Access Compliance Report

Public Rights-of-Way

Intersection ID: 3120	Main Street: DAUPHINE_DR	Cross Street: WALDEN_RIDGE_DR	Location: S
ADA ID: 4C132AACCEA5	Ramp Type: PerpDiag	Initial Pass/Fail: Fail	Overall Compliance: No
Severity Score: 8.75			
Codes/Mitigation Info/Possible Solution		Field Measurements/Component Compliance

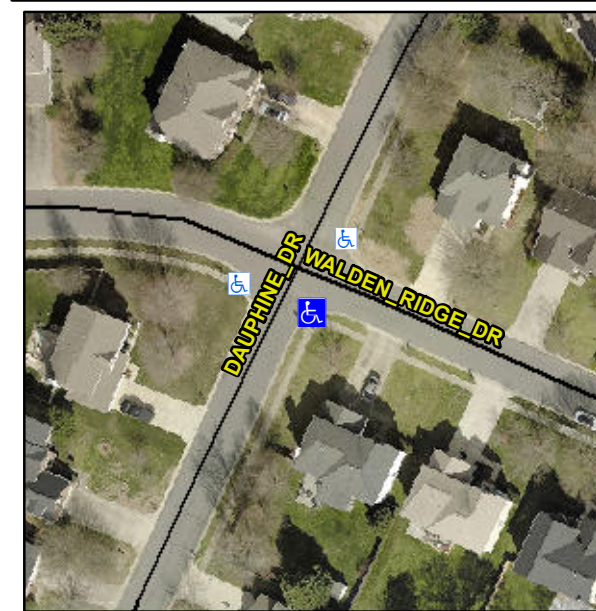
Compliance	Description	Data	Compliance	Description	Data
N/A	Ramp Length (in)	45.0	Yes	Ramp Slope (%)	7.3
No	Ramp Width (in)	45.0	Yes	Ramp XSlope (%)	1.3
N/A	Flare Type LT	N/A	N/A	Flare Type RT	N/A
N/A	Flare Slope LT (%)	N/A	N/A	Flare Slope RT (%)	N/A
N/A	Flare Traversable LT?	N/A	N/A	Flare Traversable RT?	N/A
N/A	Landing Length (in)	N/A	N/A	DWS Provided?	N/A
N/A	Landing Width (in)	N/A	N/A	DWS Contrast?	N/A
N/A	Landing Slope (%)	N/A	N/A	DWS Length (in)	N/A
N/A	Landing X Slope (%)	N/A	N/A	DWS Full Width?	N/A
N/A	Landing Curb? (Y/N)	N/A	N/A	DWS Offset (in)	N/A
N/A	Shared Landing?	N/A			
N/A	Gutter Ponding?	N/A	N/A	Gutter Slope (%)	N/A
N/A	Gutter Lip Ht (in)	N/A	N/A	Gutter X Slope (%)	N/A
N/A	Painted X Walk1?	No	N/A	Painted X Walk2?	No
	X Walk 1 Direction	To NE		X Walk 2 Direction	To NW
N/A	X Walk 1 Width (in)	N/A	N/A	X Walk 2 Width (in)	N/A
	X Walk 1 Slope (%)	2.8		X Walk 2 Slope (%)	1.8
	X Walk 1 X Slope (%)	3.8		X Walk 2 X Slope (%)	1.9

Remove & Replace Curb Ramp With Two New Directional Ramps or Equivalent.
